The New Piper Aircraft, Inc.
2926 Piper Drive
Vero Beach, Florida, U.S.A. 32960

SERVICE No. 1026 BULLETIN

SUBJECT:

Distribution of Parker Hannifin Airborne
Service Letter 48, "Inspection/Replacement
of dry air pump flexible couplings".

FIGURE 1

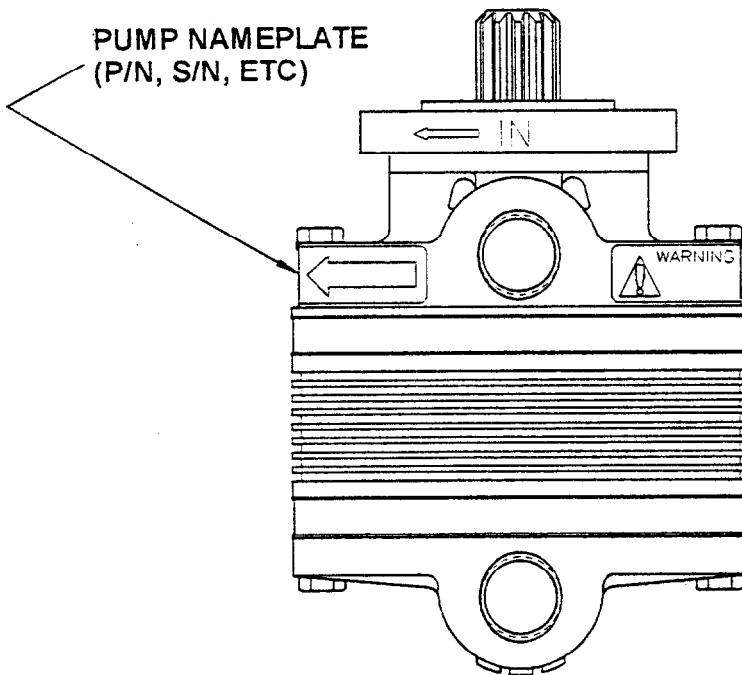
Applicability: Airborne dry air pumps, conversion kits and flexible coupling kits with the following part numbers/serial numbers which have not been inspected per this service letter as identified in step number seven of the procedure listed below. These components were shipped from Airborne between 1/1/98 and 10/13/98. Refer to Figure 1 for location of part number/serial number nameplate.

FIGURE 2

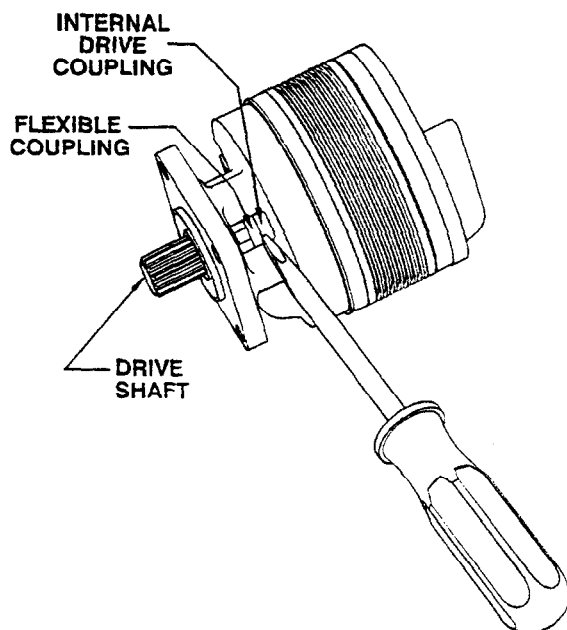
- 1) Remove dry air pump from engine accessory pad per instructions provided by the airframe manufacturer in the appropriate maintenance publication.
- 2) Insert a screwdriver or similar tool between the flexible coupling assembly (2-piece) and the pump's internal drive coupling. Remove the flexible coupling assembly from pump, taking care not to damage any of the eight drive pins. Refer to Figure 2.
